Work Order ID 89694

DRAWING NO. D412-664-243	TITLE CROSSTUBE ASSEMBLY (412 HI AFT)	REV. E	DART AEROSPACE LTD ENGINEERING ORDER		D.E.O. NO. D412-664-243-E-1	SHEET NO. SHEET 1 OF 2	SCALE NTS
DRAWN	CHECKED	MFG. APPR.	APPROVED		DE APPR.		
DATE 11.03.31	DATE 11/03/31	DATE 11.03.31	DATE 11/03/31		DATE 11.03.31

PURPOSE:

REMOVED ABRASION STRIP IN FAVOR OF A THIN LAYER OF PROSEAL 890.

**D412-664-243
ASSEMBLY DETAIL**

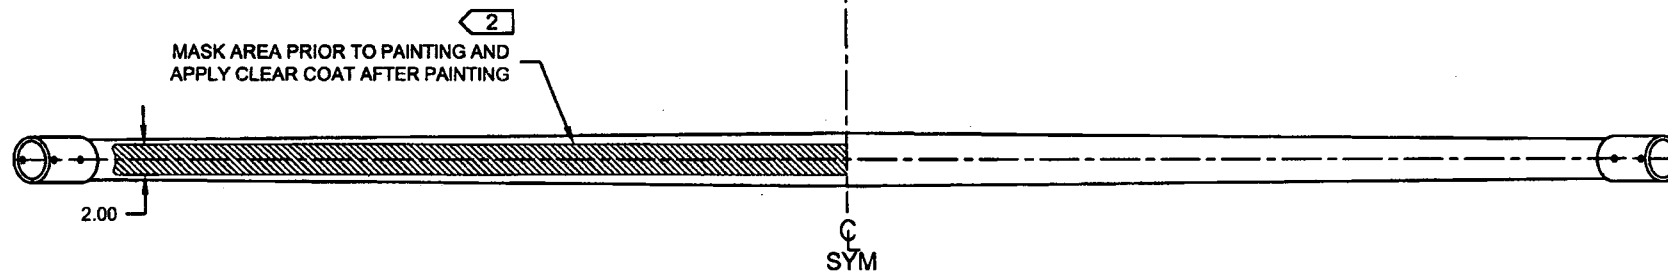
IS:

D3189-1 CHAFING SHIELD (1, INSTALLED OVER PROSEAL 890)
MS21920-28 CLAMP, 2X
2 PL

WAS:

D2856-600-1009 ABRASION STRIP
D3189-1 CHAFING SHIELD (1, INSTALLED OVER ABRASION STRIP)
MS21920-28 CLAMP, 2X
2 PL
